Planning Board Regular Meeting
Meeting date: Wednesday, May 6, 2026
Meeting Time: 7:30 PM

PLANNING BOARD MEETING AGENDA

AJDM RIVER RD

Preliminary and Final Major Site Plan Approval - proposed 4-story mixed use residential building w/100 units and retail space

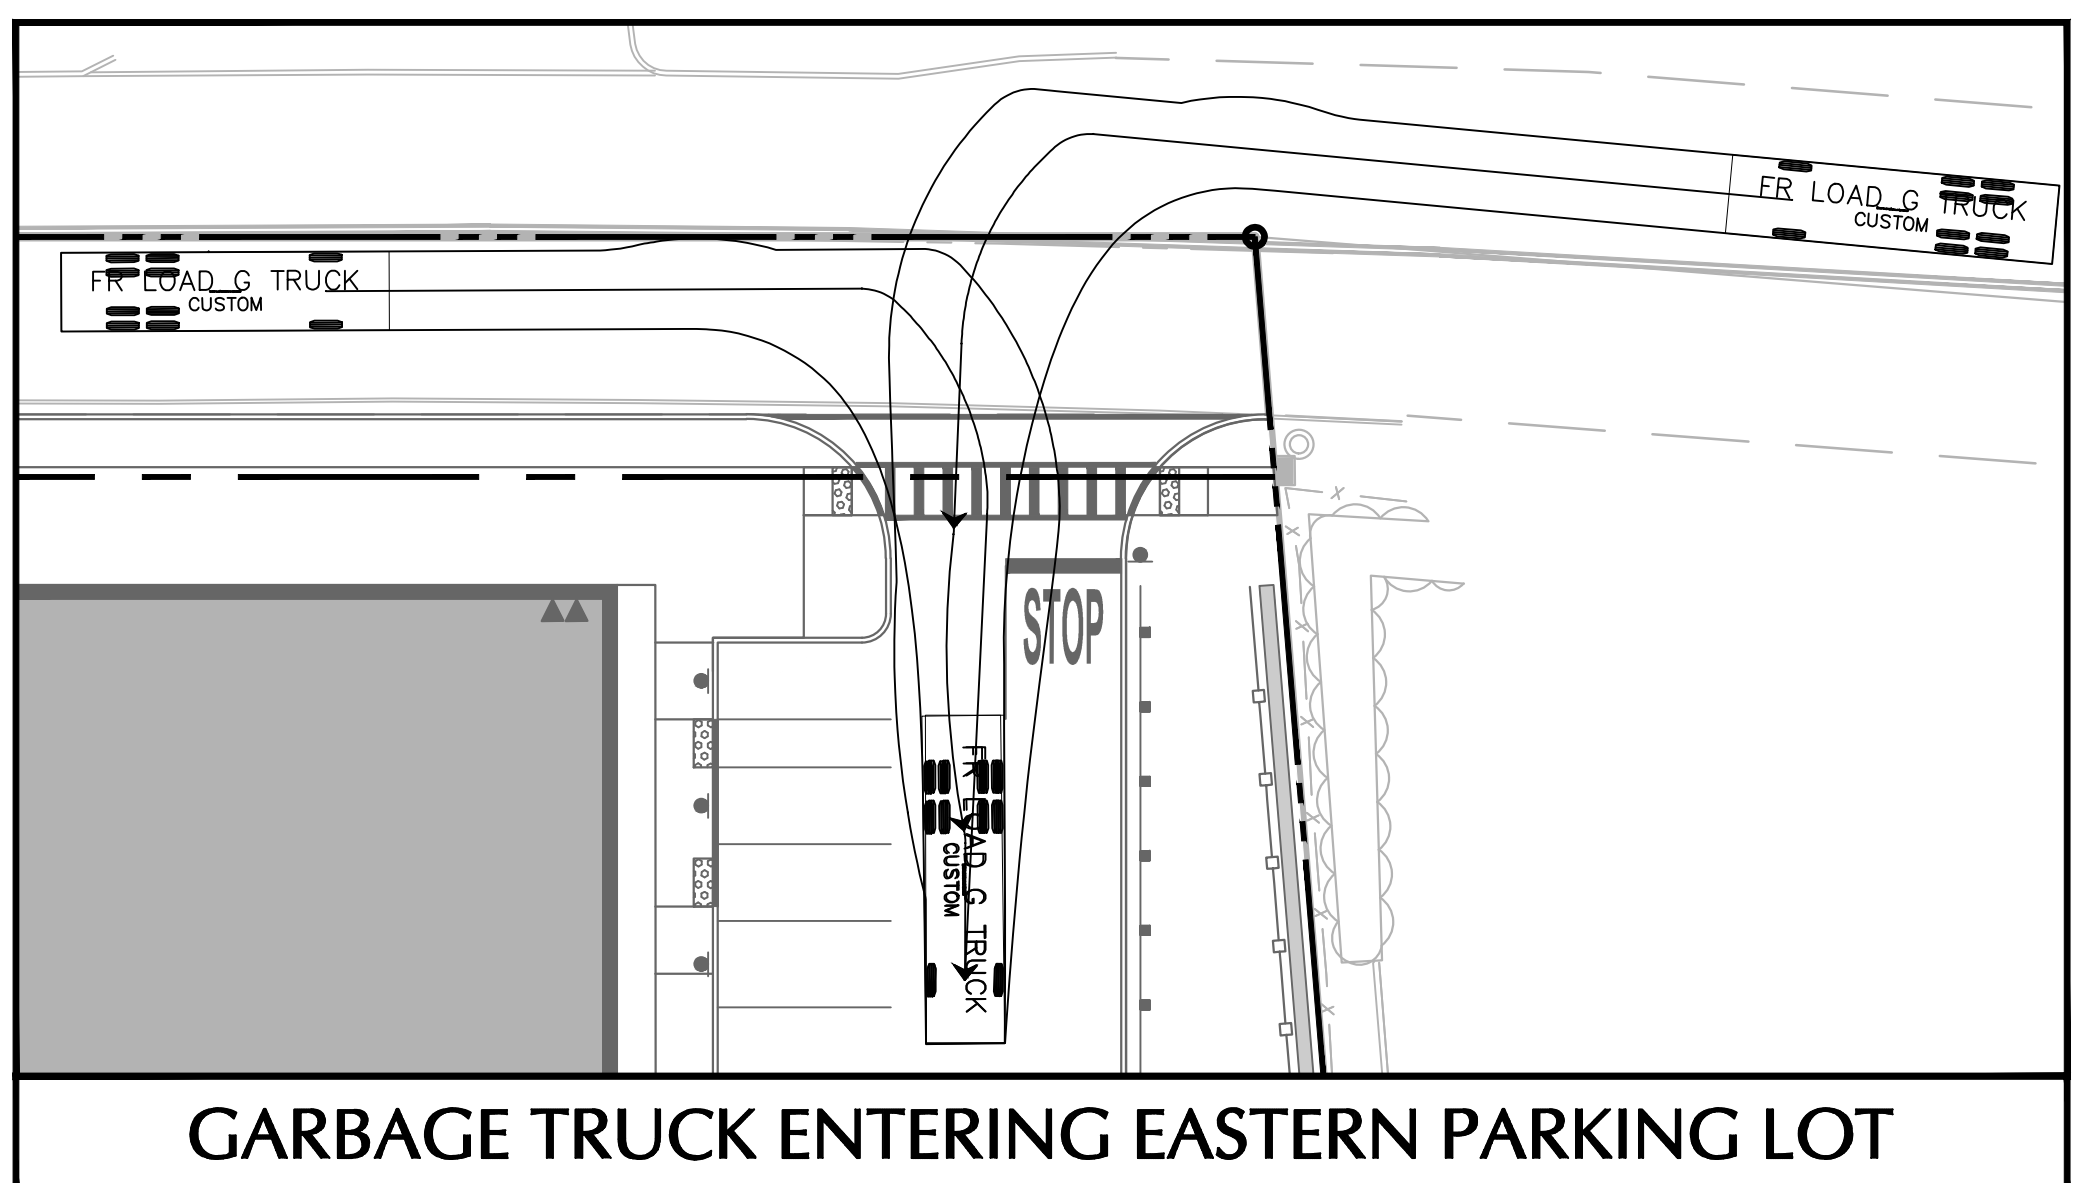
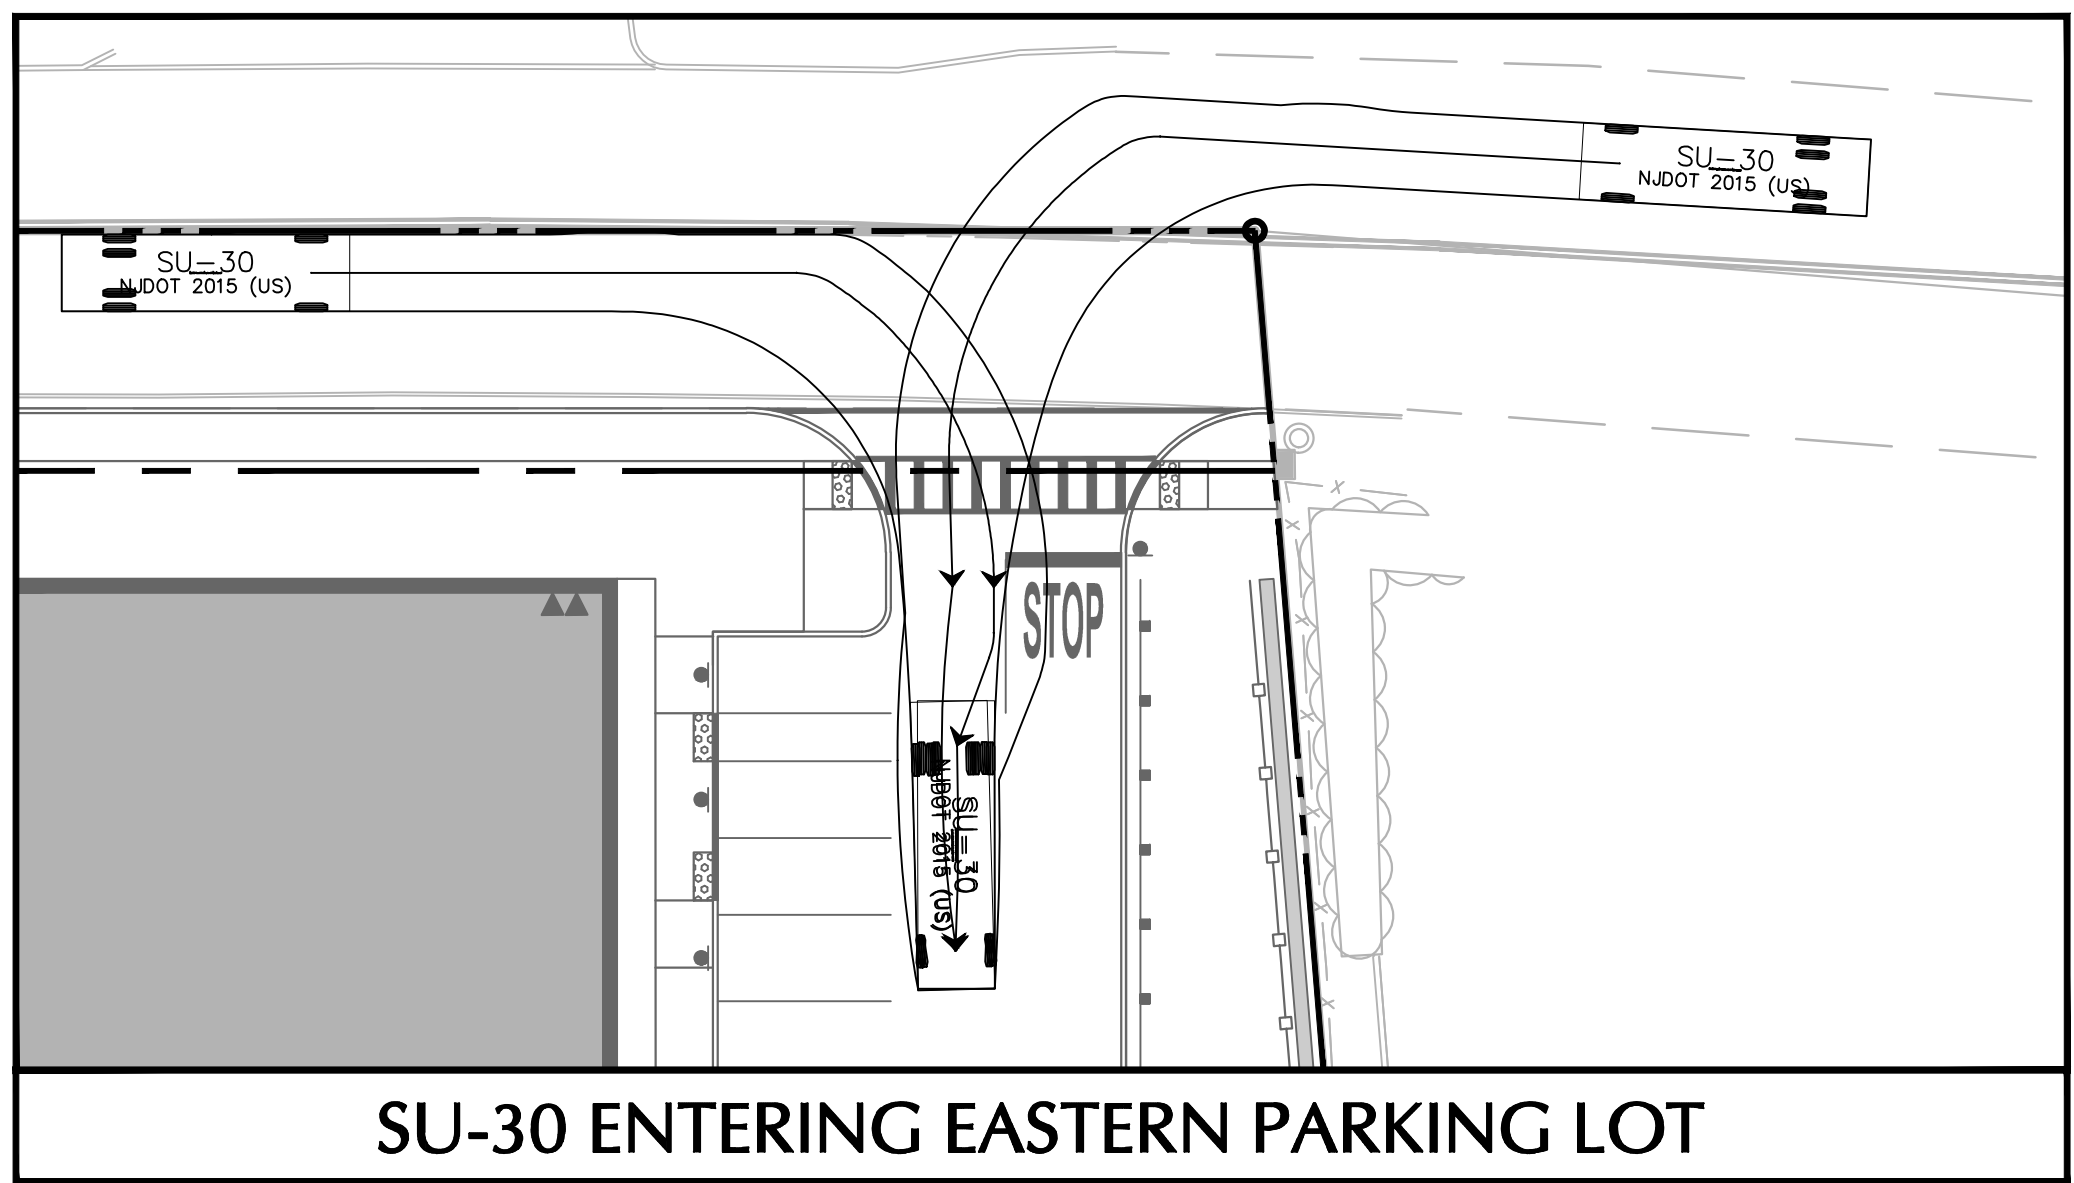
10. As indicated in the truck turning exhibits on sheet CS102, the 3-point turnaround maneuver required for garbage and typical moving trucks, while possible, will be tight. Has there been any consideration to extending the K-turn area to the northeast? By adding an additional 10 feet the k-turn area would be closer to the general rule-of-thumb of 2.5 times the length of the truck. Testimony should be provided.

A-01
 BUILDING PLAN

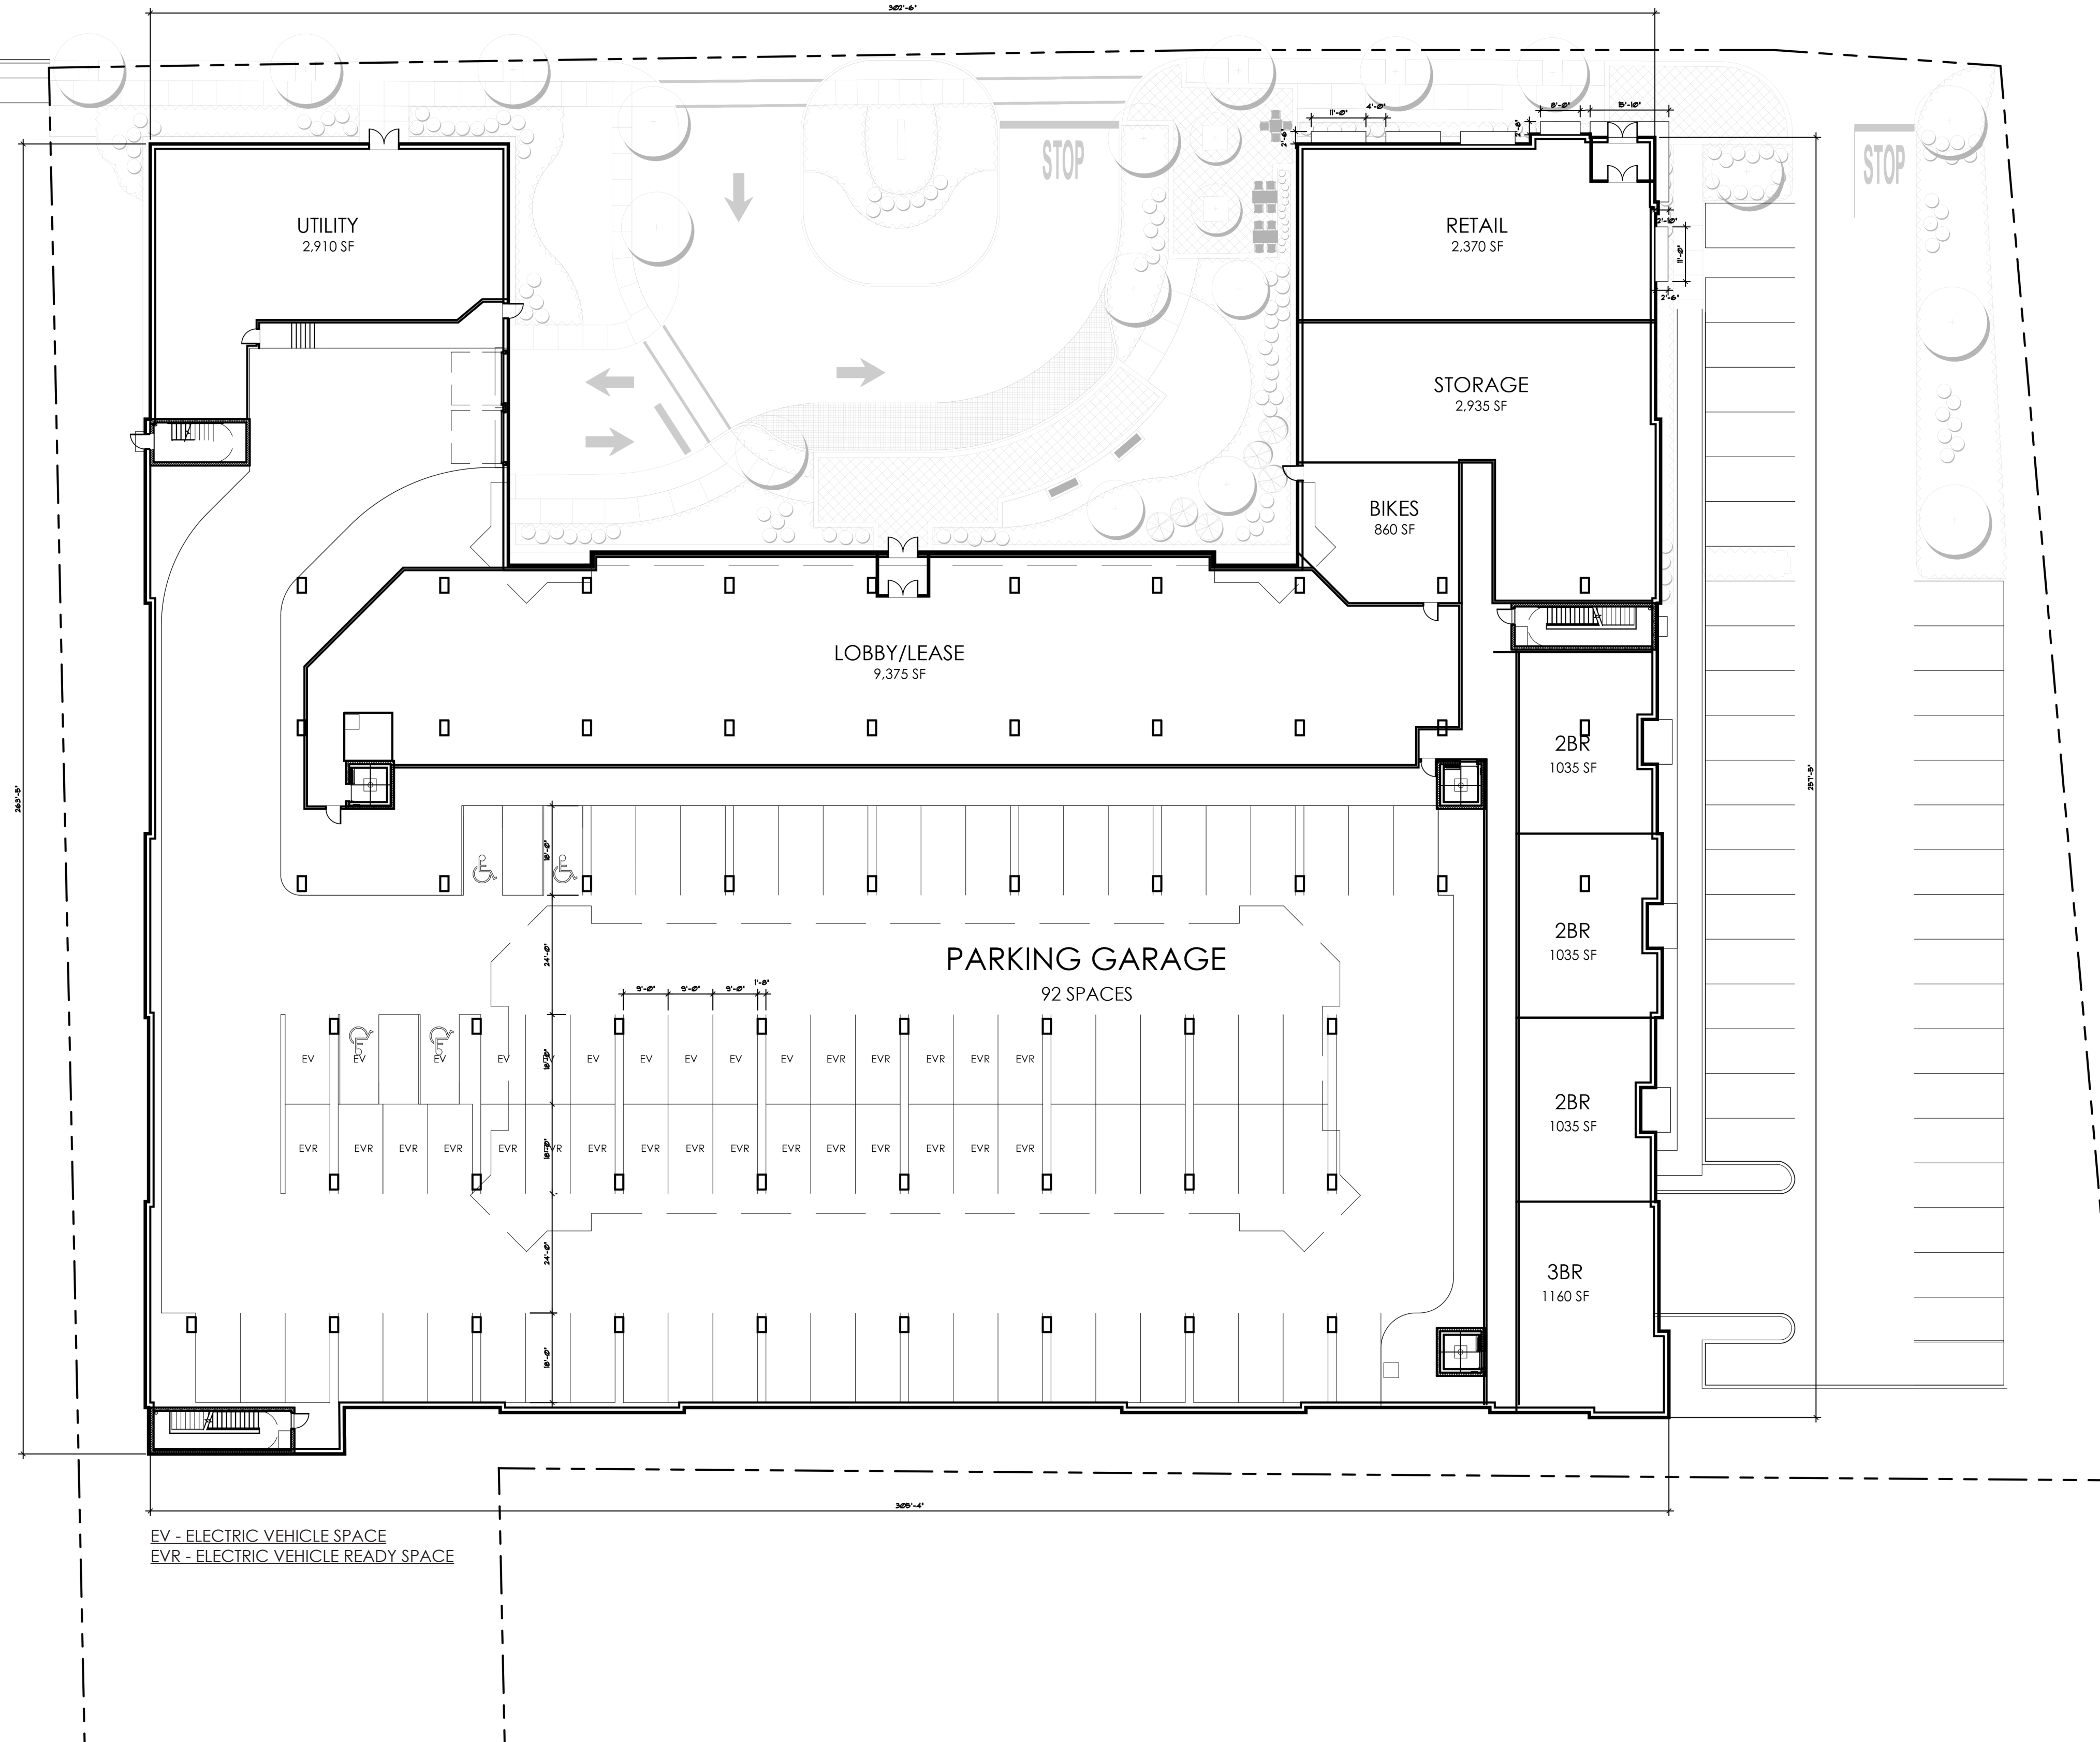
4. Stall and aisle dimensions should be provided for the ADA parking spaces shown on sheets A-01 and A-02. Also, the depth of the parking stalls at the offsets/jogs in the rear wall of both levels of the parking garage should be shown. The access aisles on sheet A-02 should be crosshatched.

7. Testimony should be provided with regard to the orientation of the elevator shown on sheet A-01 at the southeast corner of the lower-level parking garage. Will the three parking spaces block access to the elevator or the service doors? Should the space be reserved for loading/staging for move-ins rather than parking considering that 238 parking spaces are proposed and 207 spaces are required?
